Transmittal of Revision 1 to Service Bulletin V2500-ENG-75-0061

AIR - HP COMPRESSOR VARIABLE STATOR VANE ACTUATOR - INTRODUCTION OF LINEAR VARIABLE DIFFERENTIAL TRANSFORMER WITH REVISED SOLDERED TERMINATION JOINTS AND SLEEVE MATERIAL

ENGINE COMPRESSOR CONTROL - VARIABLE STATOR
VANE ACTUATOR. INTRODUCTION OF NEW LINEAR VARIABLE
DIFFERENTIAL TRANSFORMER (LVDT), WITH REVISED TERMINATION
JOINTS AND SLEEVING MATERIAL TO PREVENT JOINT DEGRADATION.

Removal and Installation of the LVDT Figure 1

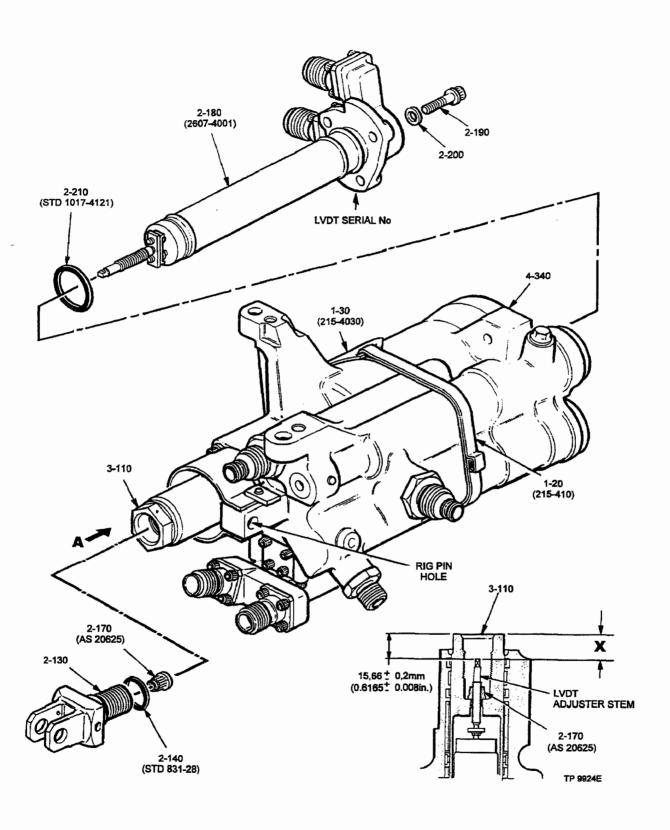
R	(5)	Remov	ve the LV	/DT, Figure 1
R R		(a)		the VSVA on the workholder A043236 and attach the workholder to a lamp or hold it in a vice.
R R R		(b)	position	the ram piston (piston assembly) (3-110) by hand to the fully extended n. Use the reaction tool (of tool A043321), to hold the ram piston and w the fork end with the torque adapter.
R R R		(c)	the ran	re the fork end (2-130) together with the toroidal sealing ring (2-140) from n piston (3-110). Remove the toroidal sealing ring (2-140) from the fork 130); discard the toroidal sealing ring.
R R R R		(d)	LVDT (while th	we and remove the self-locking nut (2-170) from the adjuster stem of the (2-180). Use the adjusting tool A043222 to hold the LVDT adjuster stem the self-locking nut (2-170) is unscrewed at the same time. Discard the sking nut (2-170).
			Note:	Use the adjuster part of the tool to hold the LVDT adjuster stem; use he sleeve socket to turn the nut.

R R		(e)		w the LVDT adjuster stem from the ram piston (3-110) (clockwise when from arrow A); use the adjuster part of the tool A043222.
R R R		(f)	washer	w and remove the three machine bolts (2-190) and the countersunk rs (2-200); these components secure the LVDT (2-180) to the body bly (4-340).
R R		(g)		re the LVDT (2-180) from the body assembly (4-340). Remove the toroidal ring (2-210) from the LVDT; discard the toroidal sealing ring.
R		(h)	Attach	a label to the removed LVDT; the label must contain this data:
				VED FROM UNIT SERIAL No. 2607*** IOURS RUN:
			Note:	2607*** as shown on the data plate (1-30). The unit hours run should be added if this is known or can be got from the operator.
R	(6)	install t	the Repla	acement LVDT, Figure 1
R R R		(a)	protecti	ly remove the replacement LVDT (2607-4000) or (2607-4001) from the ive package. If the Supplier's Certificate is with the LVDT, make sure that ial Number on the Certificate is the same as that on the flange of the

LVDT Output Voltage Checks Figure 2

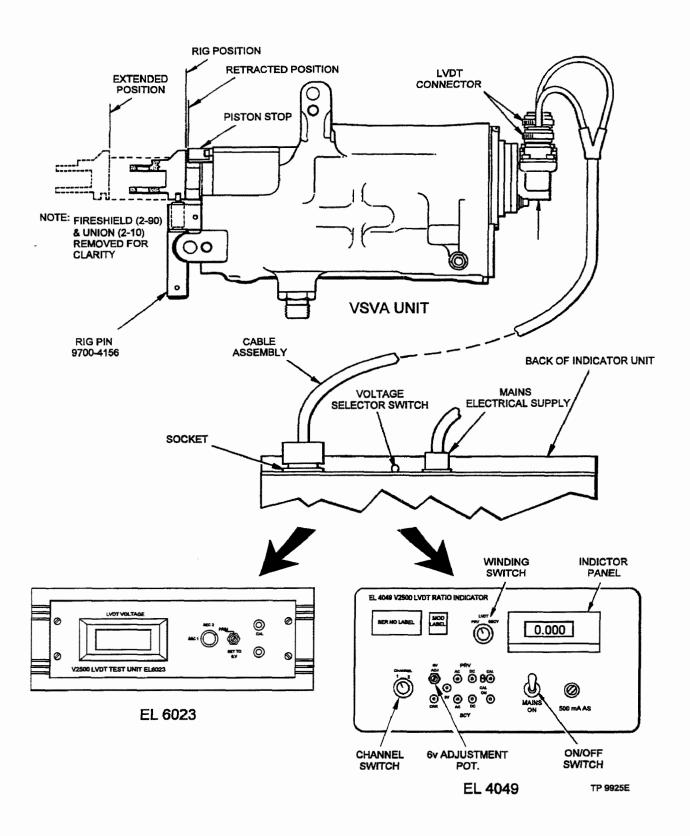
-			e.g.	Channel 1 voltage a		2.675v 2.650.
					Difference:	+0.025v
			This show position.	vs that the LVDT outp	out voltage must b	e reduced by 0.025v at the rig
R	(8)	Adjust	the LVDT o	output voltage, Figure	es 1 and 2.	
R R R		(a)	extended (5),(b) an	position and remove	the fork end (2-13 nel switch to the C	iston (3-110) to approximately the 30) as described in sub. para. CHANNEL 1 position and read the
		CAUTI		O NOT MOVE THE R HE ADJUSTMENT PR		THE STROKE MODE, DURING
R R R		(b)	output vo		43222. Use the re	stem of the LVDT to adjust the eaction tool of tool A043321 to
		Note:	A), REDU		ated output voltag	stem (when viewed from arrow ge. Clockwise rotation
R R R		(c)	value cald	culated at sub. para. ((7),(i) or (7) (l) as a turned. When the	ce the indicated voltage by the applicable. Monitor the output ne required voltage is indicated, 5 Nm (102 lbf. in.).
R R R		(d)	(3-110) (0			end face of the ram piston ension down in case no further

Removal and Installation of the LVDT Figure 1

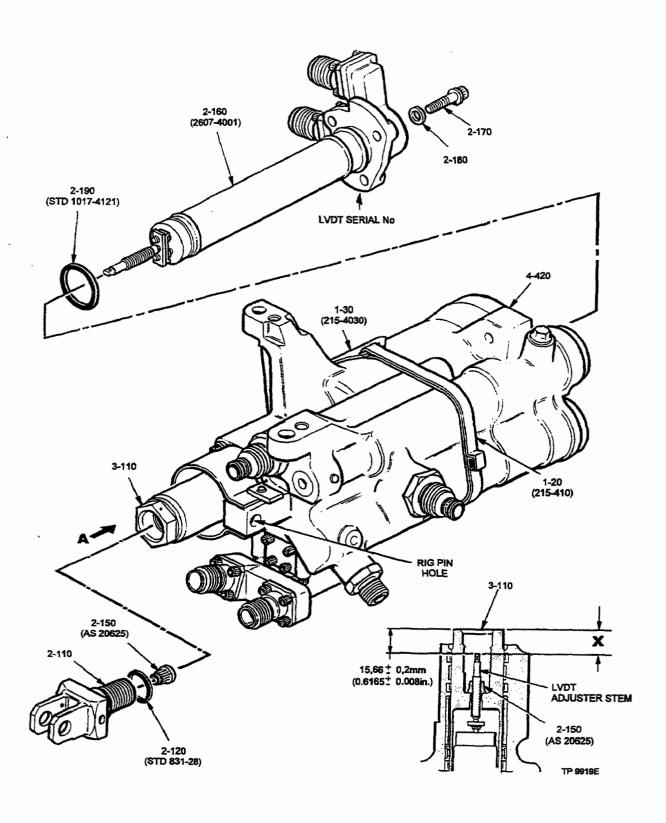
R R			Note: Use the adjuster part of the tool to hold the LVDT adjuster stem; use he sleeve socket to turn the nut.
R R		(e)	Unscrew the LVDT adjuster stem from the ram piston (3-110) (clockwise when viewed from arrow A); use the adjuster part of the tool A43222.
R R R		(f)	Unscrew and remove the three machine bolts (2-170) and the countersunk washers (2-180); these components secure the LVDT (2-160) to the body assembly (4-420).
R R		(g)	Remove the LVDT (2-160) from the body assembly (4-420). Remove the toroidal sealing ring (2-190/2-190A) from the LVDT; discard the toroidal sealing ring.
R		(h)	Attach a label to the removed LVDT; the label must contain this data:
			REMOVED FROM UNIT SERIAL No. 1685*** UNIT HOURS RUN:
R R			Note: 1685*** as shown on the data plate (1-30). The unit hours run should be added if this is known or can be got from the operator.
R	(6)	install t	he Replacement LVDT, Figure 1

R R R		(a)	Carefully remove the replacement LVDT (2607-4000) or (2607-4001) from the protective package. If the Supplier's Certificate is with the LVDT, make sure that the Serial Number on the Certificate is the same as that on the flange of the LVDT.
		CAUTIO	ON: KEEP THE SUPPLIER'S CERTIFICATE AVAILABLE THROUGHOUT THE REMAINDER OF THESE INSTRUCTIONS.
R R R	٠	(b)	Write on the Supplier's Certificate (if available), the serial number of the VSVA unit into which the LVDT is to be installed (1685*** - see the Note at sub. para. (5),(h)).
R R		(c)	Remove the LVDT from the polythene bag and clean all the surfaces with a dry, lint-free cloth.

LVDT Output Voltage Checks Figure 2

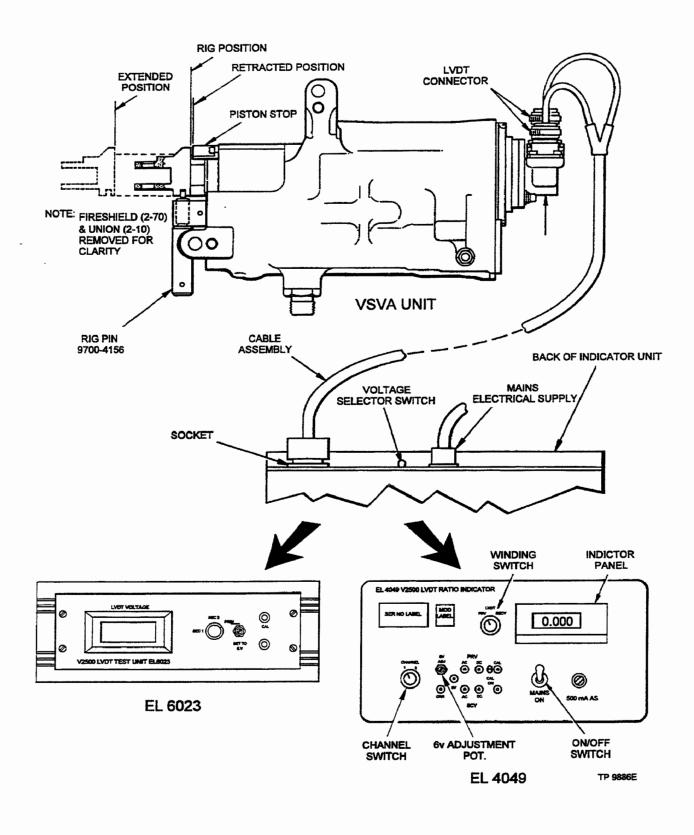
R R		(j)				e, compare the Channel 1 and 2 the nominal voltages as follows:
R R				1 voltage: 2.650±0.00 2 voltage: 2.650±0.00		
R R		(k)				n sub. para. (j), check the output s (sub. paras. (8) (i) and (l)).
R R		(I)				in sub. para. (j), calculate the the Channel 1 voltages only):
R R			e.g.	Channel 1 voltage of Channel 1 nominal		2.675v 2.650.
R					Difference:	+0.025v
R R			This show position.	vs that the LVDT outp	out voltage must b	e reduced by 0.025v at the rig
R	(8)	Adjust	the LVDT o	output voltage, Figure	es 1 and 2.	
R R R R		(a)	extended (5),(b) and	position and remove	the fork end (2-1) nel switch to the C	iston (3-110) to approximately the 10) as described in sub. para. HANNEL 1 position and read the
R R		CAUTIO		O NOT MOVE THE R IE ADJUSTMENT PF	-	HE STROKE MODE, DURING
R R R		(b)	output vol	•	3222. Use the rea	stem of the LVDT to adjust the action tool of tool A43321 to
R R R		Note:	A), REDU		ated output voltag	stem (when viewed from arrow e. Clockwise rotation

R R R R		(c)	value calc	ulated at sub. para. ((7),(i) or (7) (l) as a turned. When the	the indicated voltage by the applicable. Monitor the output are required voltage is indicated, is Nm (102 lbf. in.).
R R R		(d)	(3-110) (d			end face of the ram piston nsion down in case no further
R R R		(e)		leturn the ram piston		110), as described in sub. para. ' position and re-insert the rig pin
